APPLICATION INFORMATION		
Applicant: City of Albuquerque, Fire Department and Department of Municipal Development		Phone: (505) 768-3857
Address: PO BOX 1293		Email:
City: Albuquerque	State: NM	Zip: 87102
Professional/Agent (if any): Consensus Planning, Inc.		Phone: (505) 764-9801
Address: 302 Eighth Street NW		Email: fishman@consensusplanning.com
City: Albuquerque	State: NM	Zip: 87102
Proprietary Interest in Site:	List <u>all</u> owners: City of Albuquerque

BRIEF DESCRIPTION OF REQUEST
DRB Signoff of previously approved EPC Site Development Plan for Building Permit

The purpose of this letter is to request final DRB signoff of a Site Development Plan for Building Permit that was previously approved by the Environmental Planning Commission on October 11, 2018 for the Fire Station #9. The EPC approved the Site Development Plan for Building Permit on October 11, 2018, under the regulations of the previous City zoning code prior to the adoption of the Integrated Development Ordinance (IDO). An application for a Preliminary Plat has been submitted concurrently with this Site Plan application

Project# 1001081
18EPC-40036 Zone Map Amendment
(Zone Change)
18EPC-40037 Site Development Pl

A1 SITE DEVELOPMENT PLAN
SCALE: 1" = 20'-0"

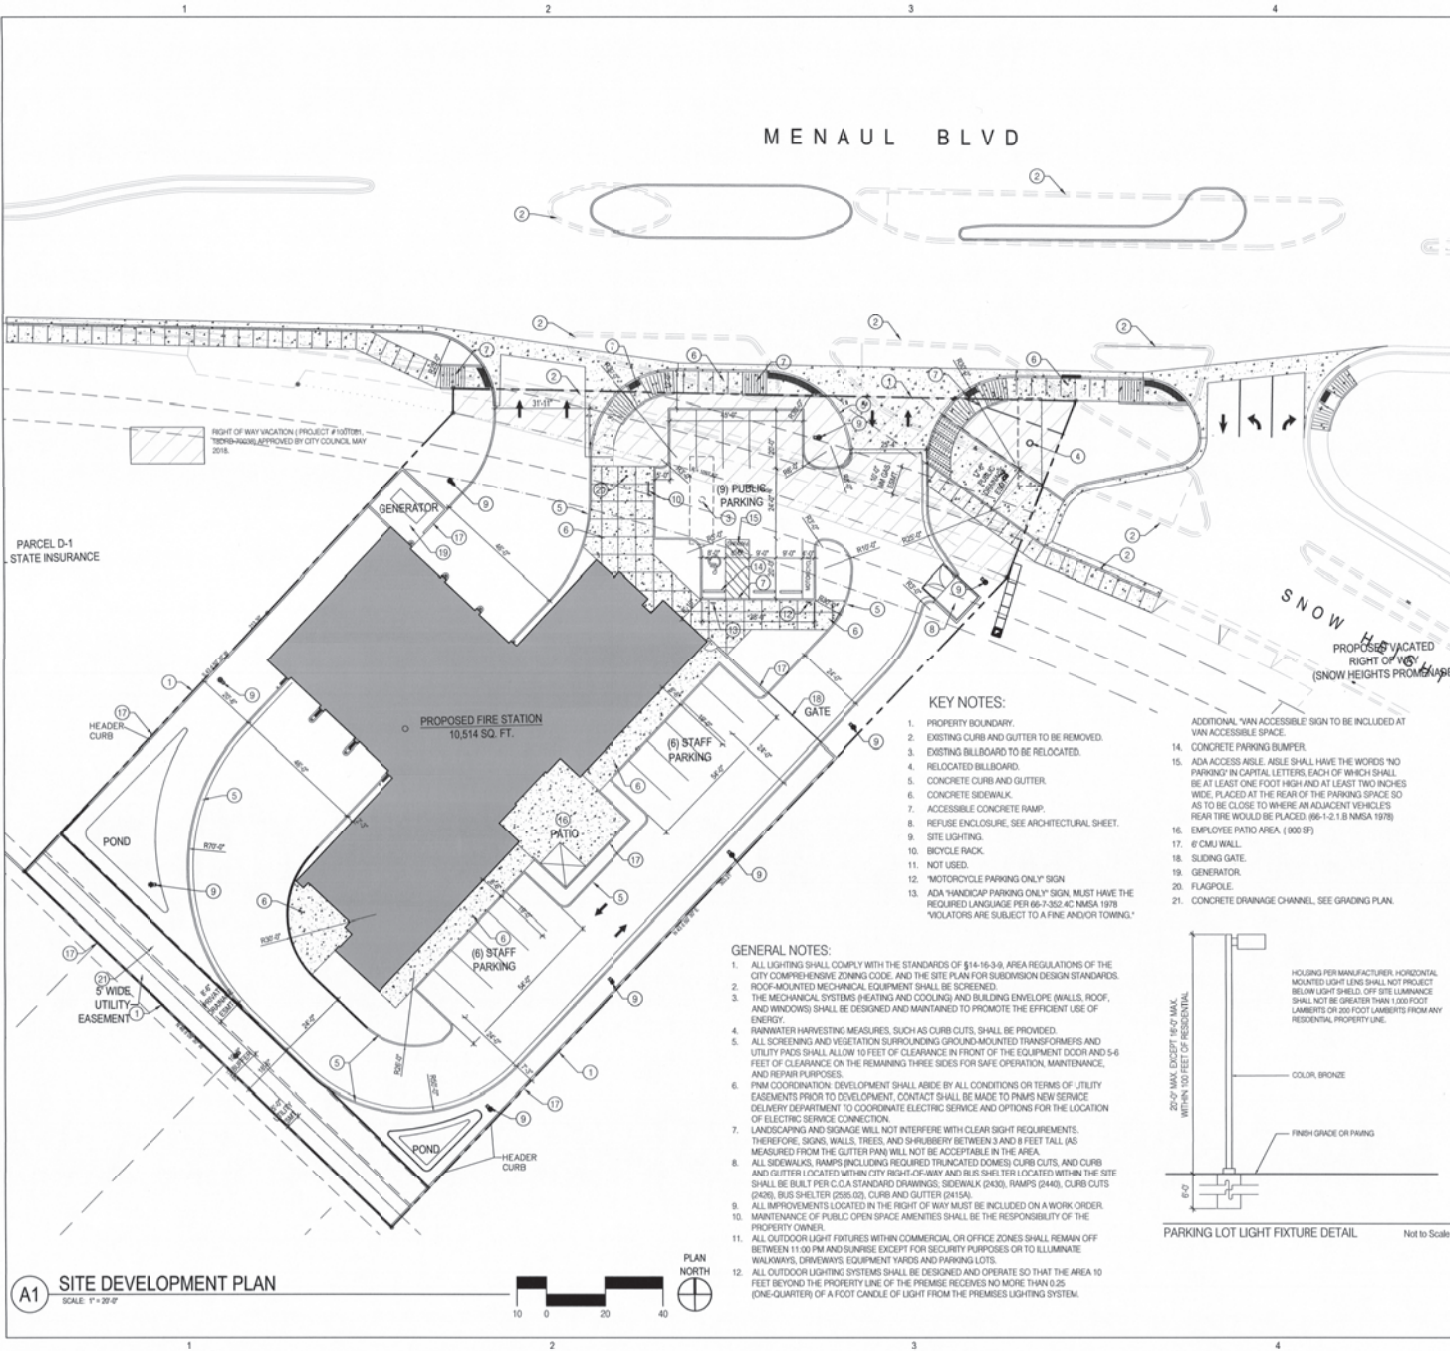
2. Prior to application submittal to the DRB, the applicant shall consult with the staff planner to ensure that all conditions of approval are met.
3. The sidewalk in front of the building shall be updated to be 8-feet wide at all points (pursuant to Zoning Code 14-16-3-1 (H) (4)).

Applicant's Response: The sidewalk at the front and adjacent to the building has been widened to at least 8 feet wide at all points. The shortest width of the sidewalk is 8 feet, 10 inches wide.

A1 LANDSCAPE PLAN
 SCALE: 1" = 20'-0"

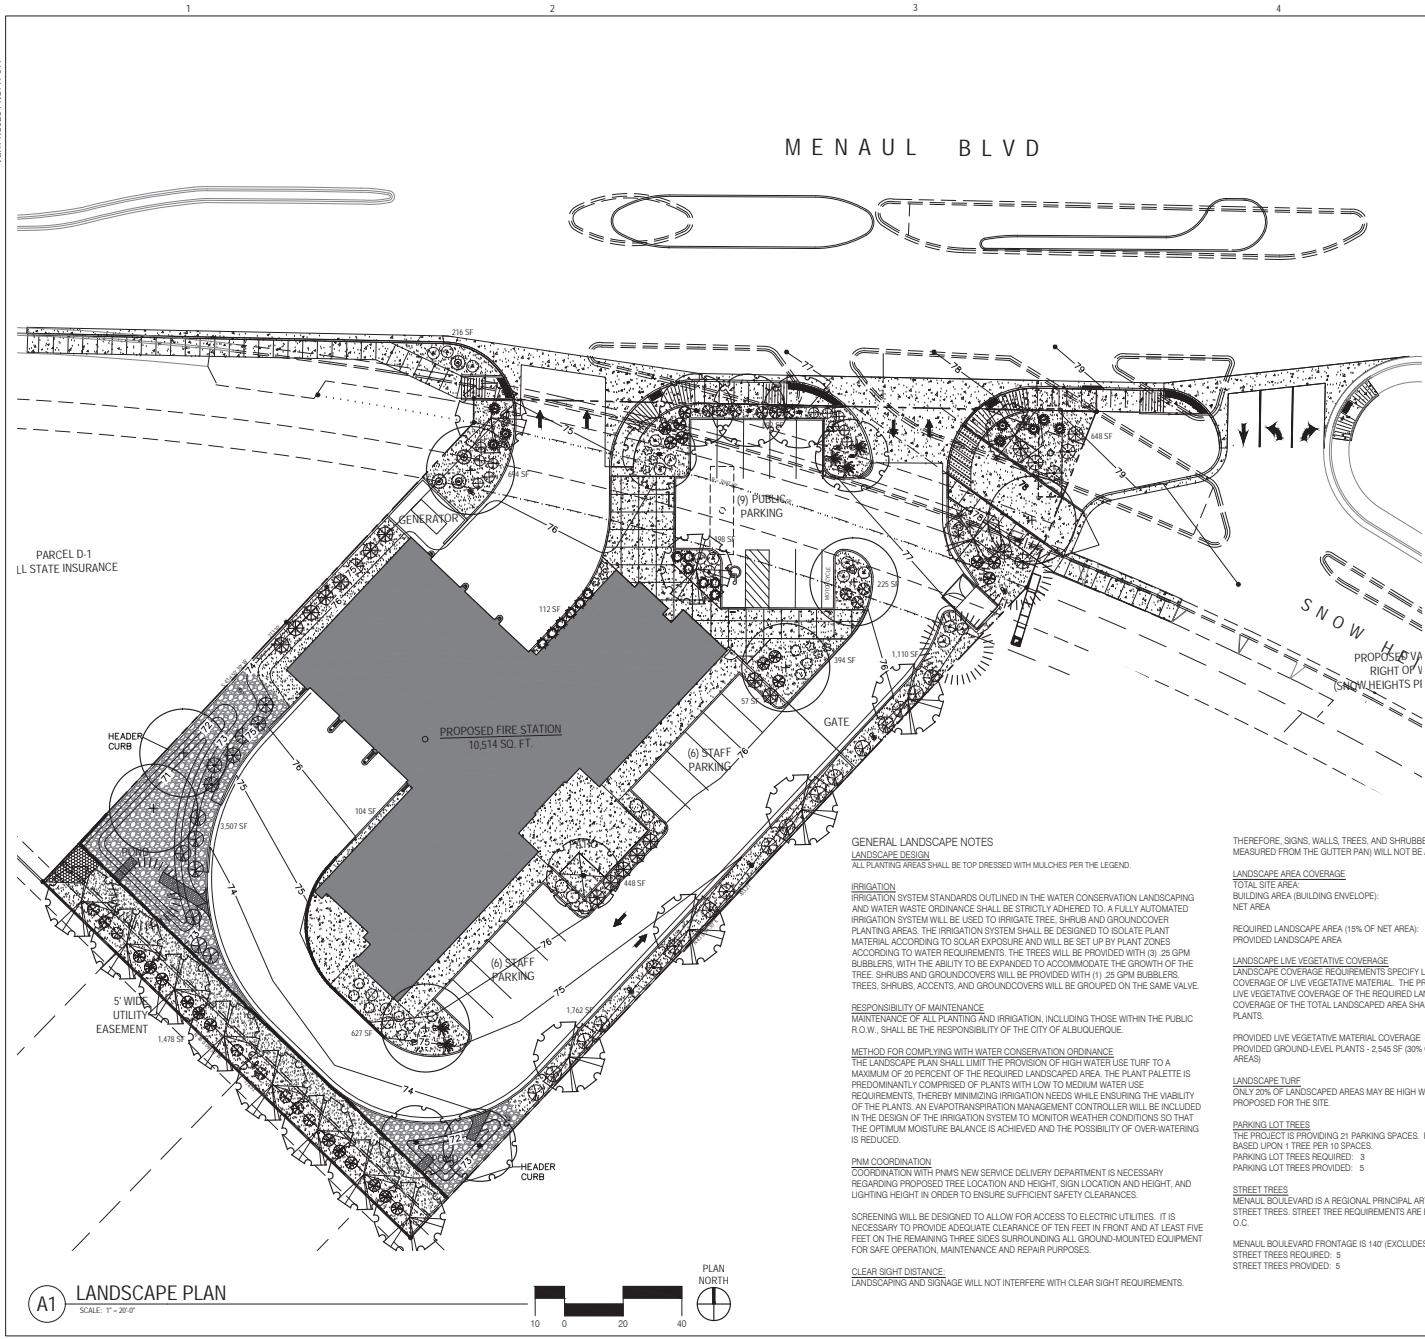
4. *Trees and vegetative cover shall be added to the landscape buffer at the southwest property line (pursuant to Zoning Code 14-16-3-10 (8)).*

southwestern boundary of the site. A shorter tree selection at mature height is necessary at this location. PNM's landscaping preference is for trees and shrubs to be planted outside the PNM easement; however, if within the easement, trees and shrubs should be located to minimize effects on electric facility maintenance and repair. New trees planted near PNM facilities should be no taller than 25 feet in height at maturity to avoid conflicts with existing electric infrastructure.

- An existing overhead distribution line is located along the southern boundary of the subject property. On the sheet entitled Landscape Plan, the proposed tree selection, Austrian Pine, is not a compatible height at maturity with the existing overhead electric distribution facility along the southwestern boundary of the site. A shorter tree selection at mature height is necessary at this location. PNM's landscaping preference is for trees and shrubs to be planted outside the PNM easement; however, if within the easement, trees and shrubs should be located to minimize effects on electric facility maintenance and repair. New trees planted near PNM facilities should be no taller than 25 feet in height at maturity to avoid conflicts with existing electric infrastructure.

Applicant's Response: Additional trees and vegetative cover have been added to the landscape buffer area along the southwest property line. Trees include eight *Acer Tataricum* 'Gar Ann' Hot Wings Maples that can reach a mature height of 20 feet and a spread of 24 feet. The buffer has also been expanded slightly from approximately 16

Applicant's Response: Agreed. In addition, Austrian Pines along the southern boundary of the site have been replaced with shorter "Hot Wings Maples," which have a mature height of 20 feet. All trees located in or near PNM easements reach a mature height of no more than 20 feet in height.

Drawing Title: **CONCEPTUAL SITE UTILITY PLAN**

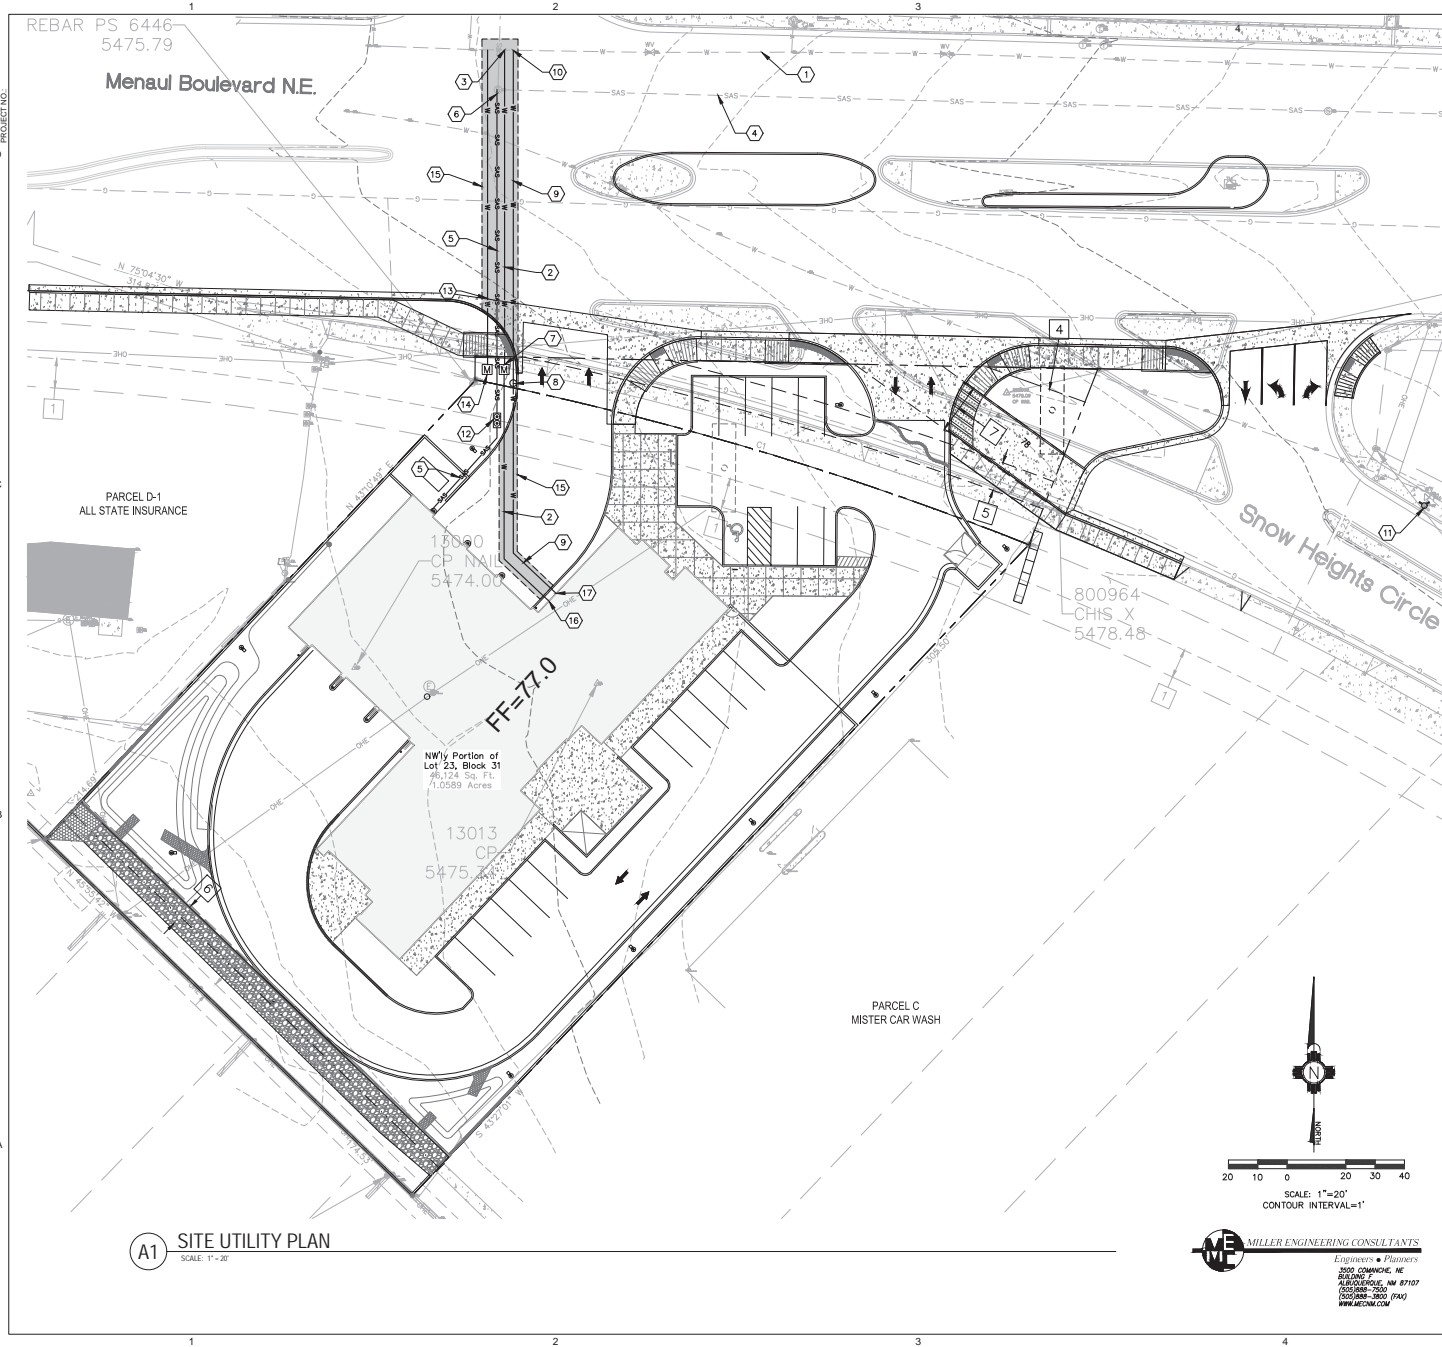
- The proposed conceptual site utility plan indicates a metered service, fire line, and new sanitary sewer service.
 - With regard to the water service: please note that the meter vault shall be located within the right-of-way.

- With regard to the fire line: please note that the private valve is to be located just within the property line.
 - Backflow prevention was not mentioned on the conceptual site utility plan. Please note that a Water Authority approved backflow prevention assembly will be required prior to service.

Applicant's Response: Agreed. In addition, a Water Availability Statement from ABCWUA and a signed Fire 1 Plan are included with the submittal package.
